### APPEAL SUMMARY

<b>Appeal ID:</b> 20397	<b>Project Address:</b> 1417 NW 20th Ave
<b>Hearing Date:</b> 5/15/19	<b>Appellant Name:</b> Ross Determan
<b>Case No.:</b> B-008	<b>Appellant Phone:</b> 503-847-2129
<b>Appeal Type:</b> Building	<b>Plans Examiner/Inspector:</b> David Bartley
<b>Project Type:</b> commercial	<b>Stories:</b> 6 <b>Occupancy:</b> A-3, B, M, R-2, S-1, S-2 <b>Construction Type:</b> I-A, III-A
<b>Building/Business Name:</b> Saltwood--North Building	<b>Fire Sprinklers:</b> Yes - Throughout
<b>Appeal Involves:</b> Erection of a new structure	<b>LUR or Permit Application No.:</b> 18-185663-LU
<b>Plan Submitted Option:</b> pdf [File 1] [File 2] [File 3]	<b>Proposed use:</b> Multi-family Residential and Retail

#### Appeal item 1

② TOWNHOUSE LEVEL 1 PLANS  
1/16" = 1'-0"

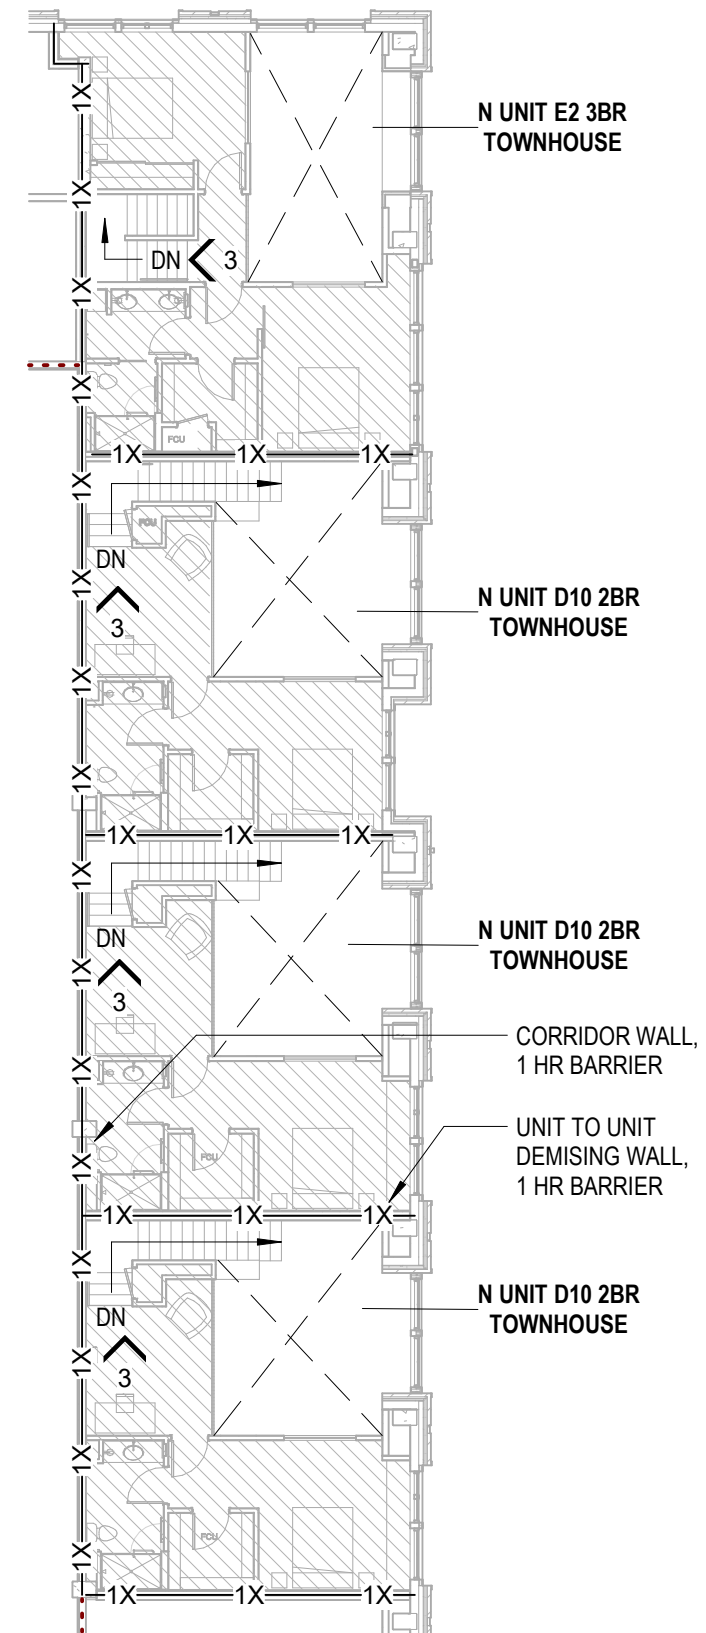
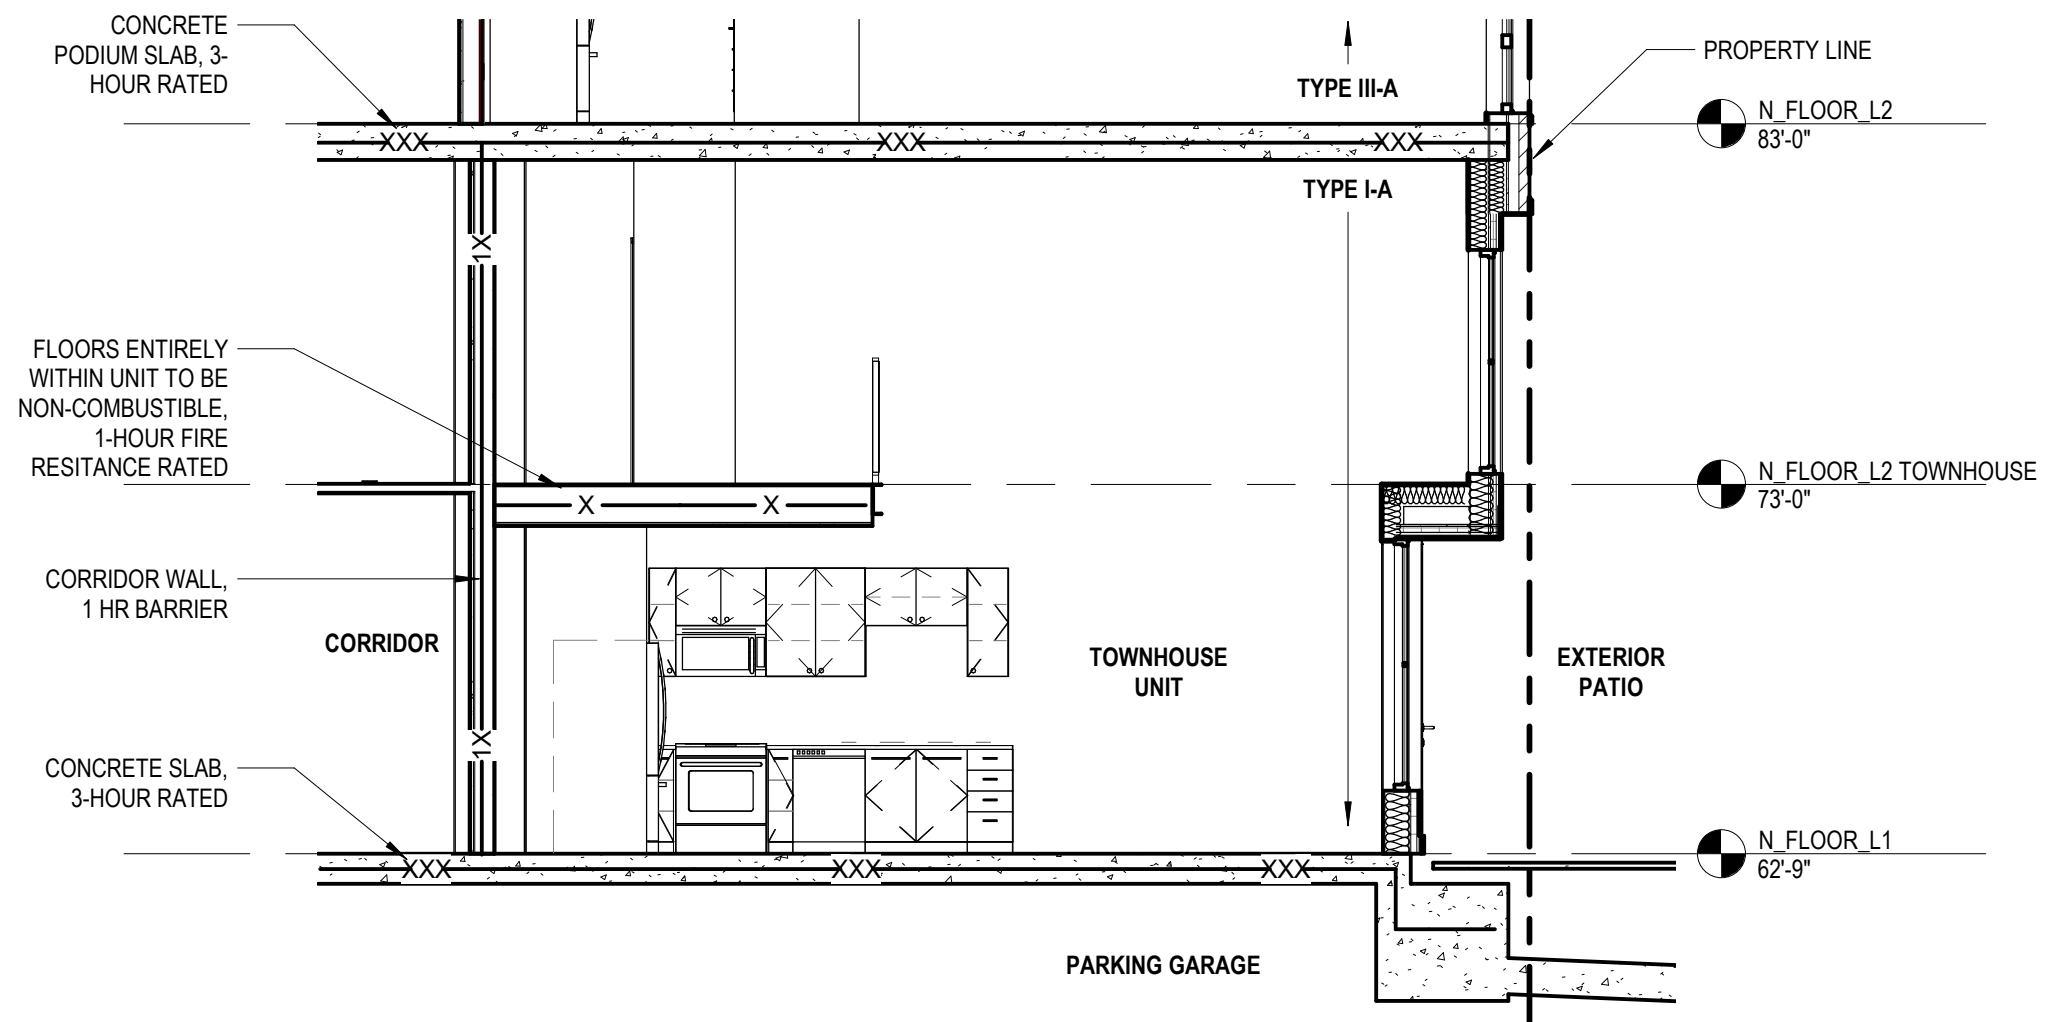
<b>Code Section</b>	2014 OSSC, Table 601, Type IA
<b>Requires</b>	Per Table 601, for construction within a Type IA building, interior bearing walls are required to be 3-hour rated and interior floor construction is required to be 2-hour rated
<b>Proposed Design</b>	<p>The project is proposing two-level townhouse units that occur only within the Type IA portion of the building on Level 1 between the 3-hour rated Level 1 slab and the 3-hour rated Level 2 slab, with the Level 2 slab serving as the required 3-hr separation between the Type IA construction and Type IIIA construction for the floors above Level 2. Each townhouse unit has 2 levels with the upstairs portion exceeding the area allowed to be considered a mezzanine and thus their upstairs are considered a story (reference approved Appeal ID 20126). The units are equipped with an approved NFPA 13 automatic sprinkler system and will have all required smoke, Carbon Dioxide and audio/visual alarm detection provided.</p> <p>The project proposes the townhouse unit upper floor assembly and the associated bearing walls supporting the townhouse upper floors be 1-hour construction in lieu of the ratings prescribed in Table 601 for Type 1A construction for bearing walls and floors, as prescribed above. To offset this proposed reduction in rating, we propose exceeding baseline code by making the corridor and demising walls surrounding the townhouse units 1-hour Fire Barriers with 45-minute rated doors (where occurs), in lieu of ½ -hour rated corridor walls with 20-minute rated entry doors. See attached exhibits.</p>

<b>Reason for alternative</b>	Though technically too large to be considered mezzanines, the upper levels of the townhouses are constructed like a mezzanine with a double-height open-to-below area at the living rooms. The townhouse upper floors are supported entirely by non-combustible framed bearing walls that are completely independent of and do not contribute to the primary concrete structure of the Type IA

building. Each townhouse upper floor and associated bearing walls occur inside the 1-hour rated fire barriers proposed above, isolating them from the other adjacent areas of the building. The proposed townhouse dwelling units each have a low occupant load (each less than 5 occupants) and the occupants have familiarity with their unit and where the exits are located. Each townhouse unit provides two exits, with one directly to the exterior at grade. The project is fully equipped with an approved NFPA 13 automatic sprinkler system and all required smoke, Co2, and alarm detection systems. The proposed design offers substantial fire protection for the proposed use and meets the assumed intent of the code.

**Reduction in townhouse floor assembly and bearing walls from 2 hours to 1 hr: Denied. Proposal does not provide equivalent Life Safety protection.**
